LETTER REPORT ON
ADVANCED PLANNING
OF
THJORSA DIVERSION FEATURES

BURFELL PROJECT

PREPARED FOR
THE STATE ELECTRICITY AUTHORITY
GOVERNMENT OF ICELAND
MAY 1963

Subject: Burfell Project
Thjórša Diversion
Features

GRAPHIC CORE LOGS
SHEET 9 of 10

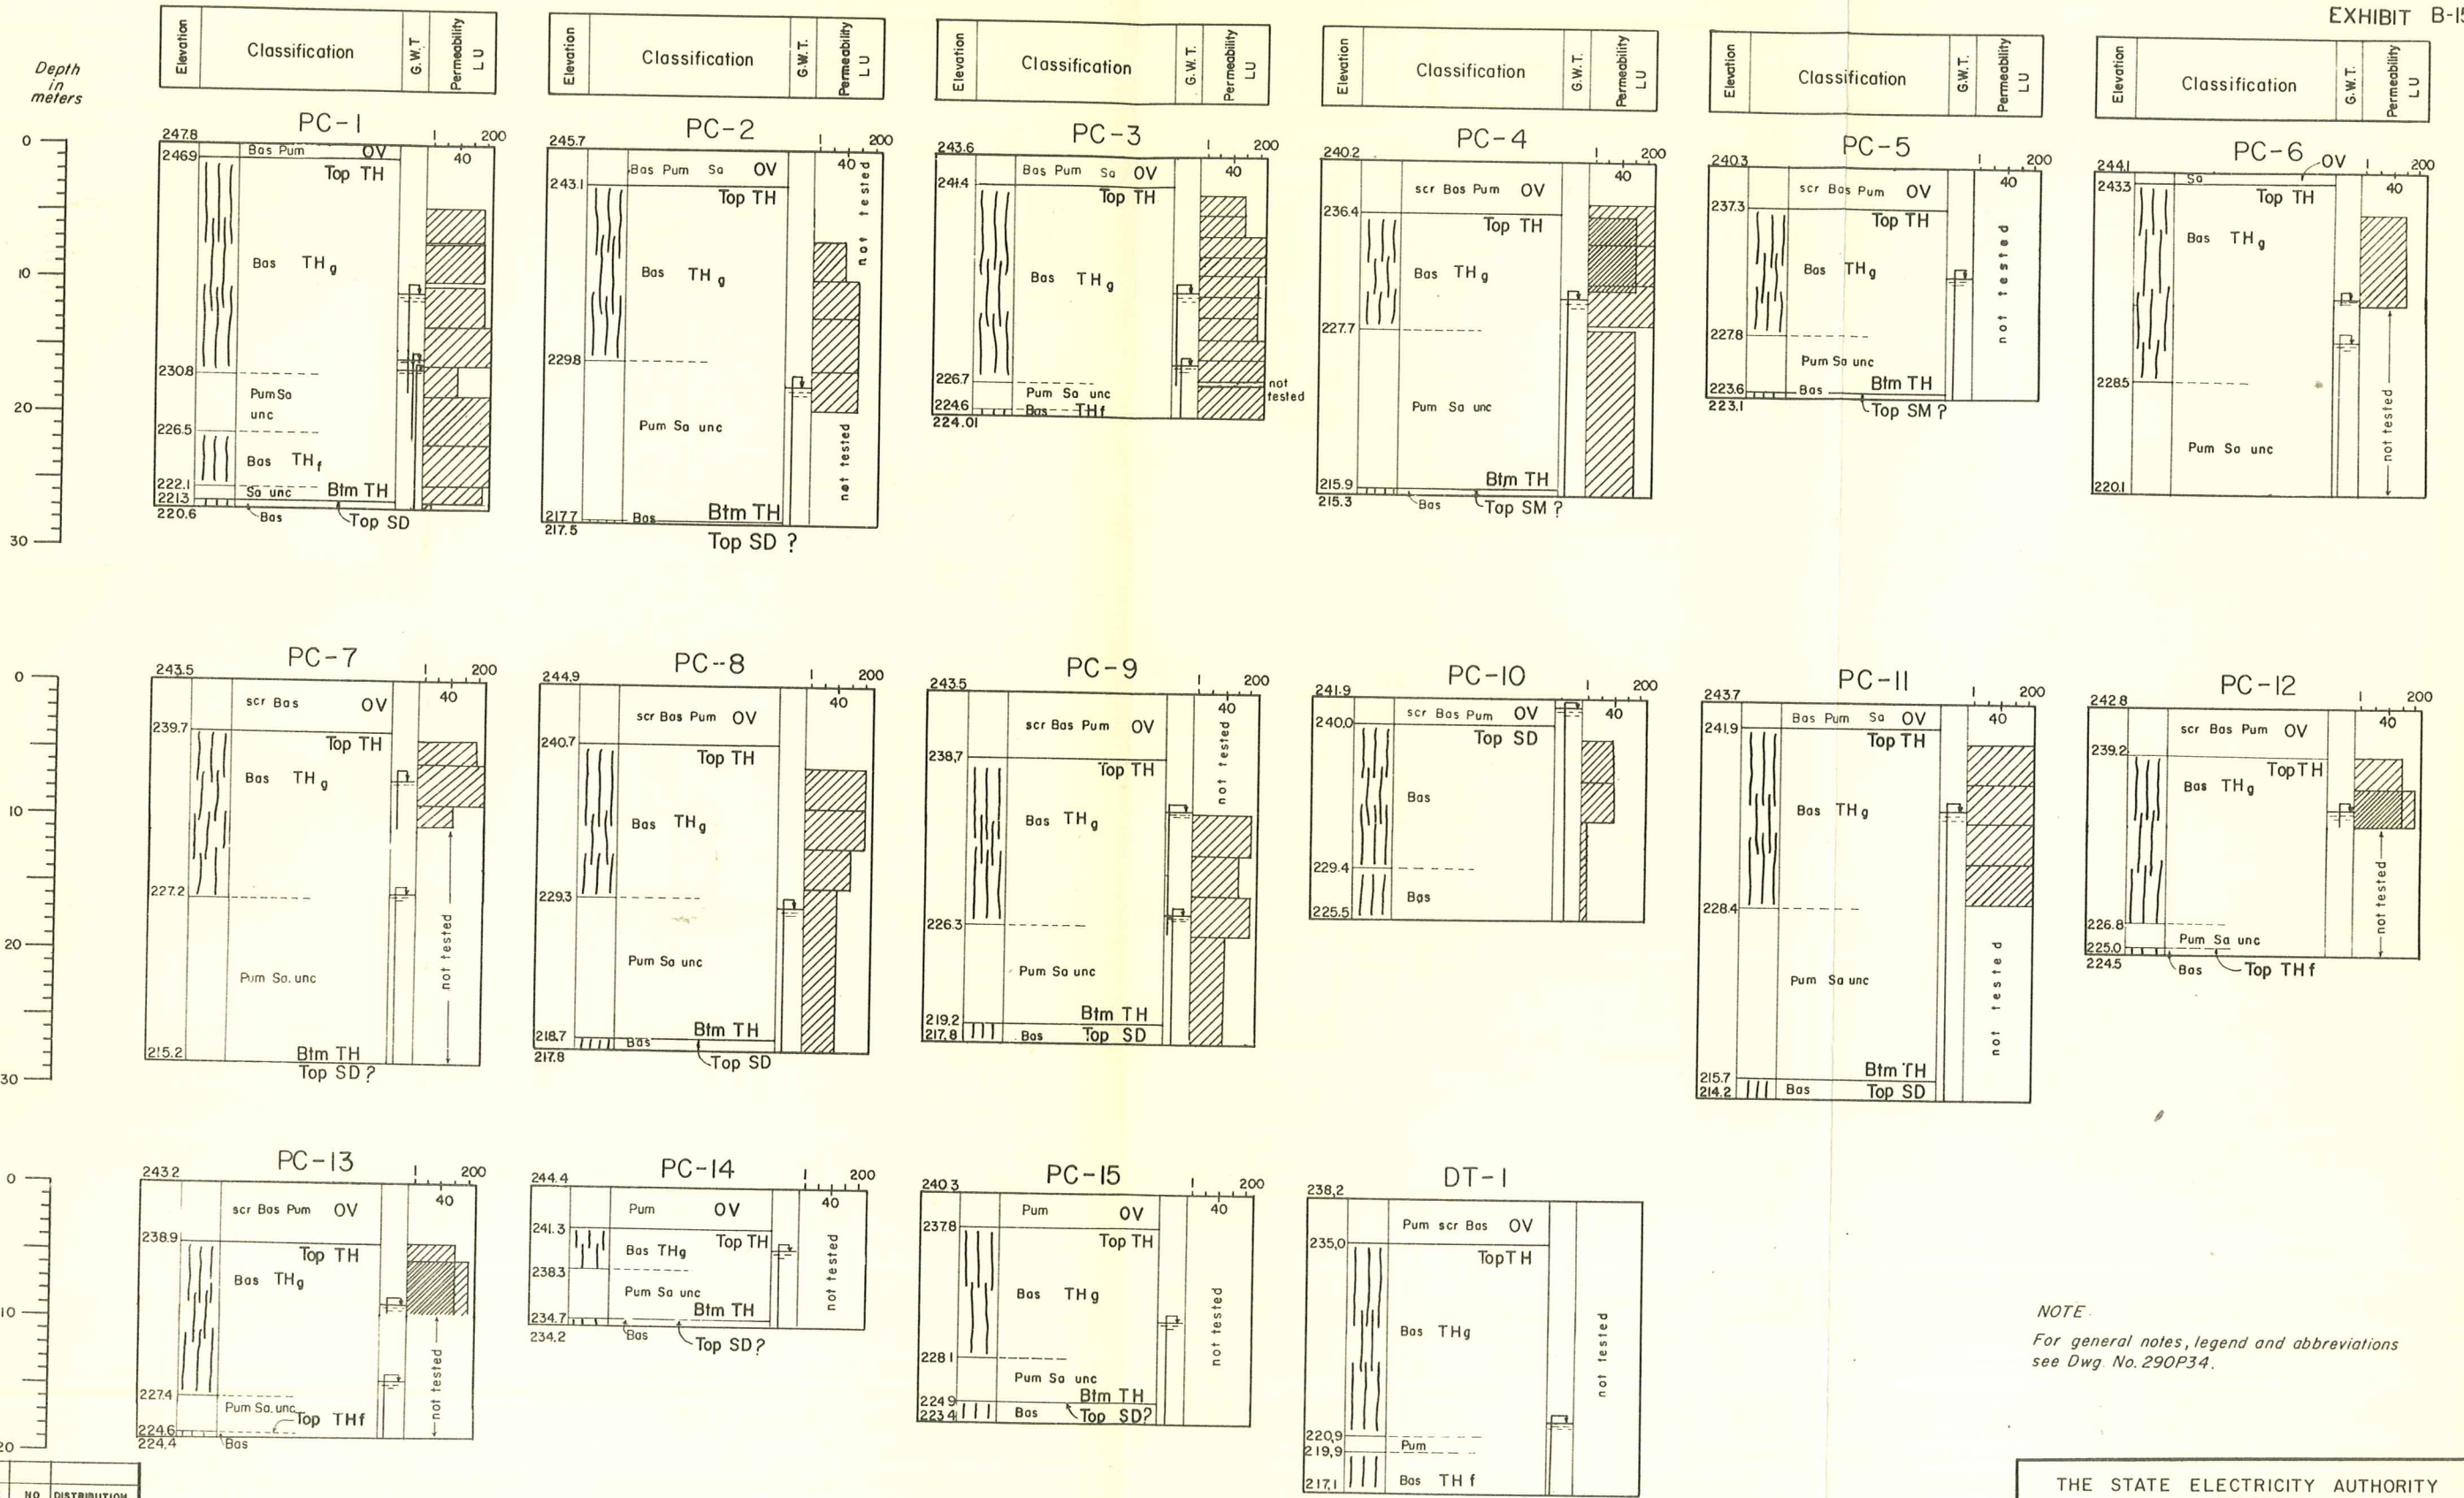
Four of the core borings accomplished in 1962 were deepened, and three new holes were drilled. All are located in the general area of the Diversion Structures. Holes PC-6, 7, 12, and 13 were deepened

REV. NO.	DATE	NATURE OF REVISION	BY	CHKD.	APPD.
1	4-17-63	Corrected PC-2, PC-8. Extended depth PC-6, 7, 12, 13. Added PC-14, PC-15	NLS	G2D	RSJ
